Town of Los Gatos

Request for Proposals – Oak Meadow Bandstand Area Improvements Questions and Answers 11/22/2021

Stairs : Risers Striping Width

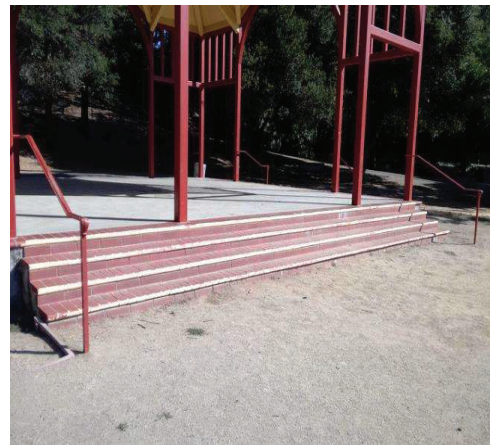
There is detectable striping affixed to each tread of the stairway, however the strips do not contrast in color from that of the treads or are not at least two inches in width.

On-Site Finding 1.00 inches

Replace the detectable striping on each tread of the stairway with detectable striping that clearly contrasts in color and is at least 2 inches in width placed no more than 1 inch from the tread nose or landing.

Recommendation 2.00 - 4.00 inches

Stairs : Handrail Diameter

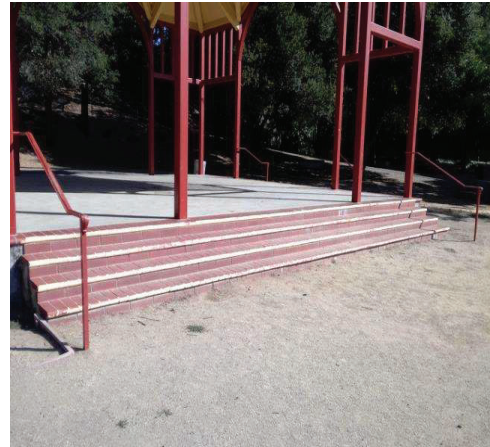
The diameter of the handrails is not within the required range.

On-Site Finding 2.25 inches

Replace the handrails on each side to provide a smooth and continuous gripping surface diameter within the required range.

Recommendation 1.25 - 2.00 inches

Stairs : Handrail Diameter

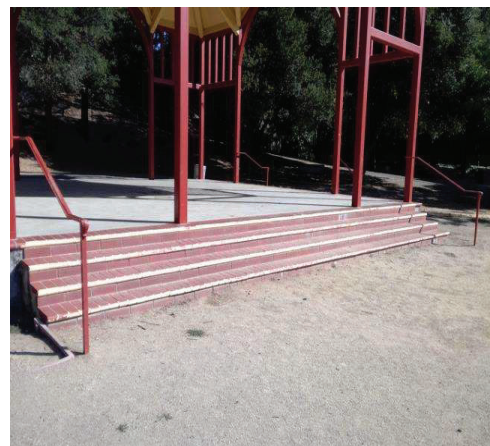
The diameter of the handrails is not within the required range.

On-Site Finding 2.25 inches

Replace the handrails on each side to provide a smooth and continuous gripping surface diameter within the required range.

Recommendation 1.25 - 2.00 inches
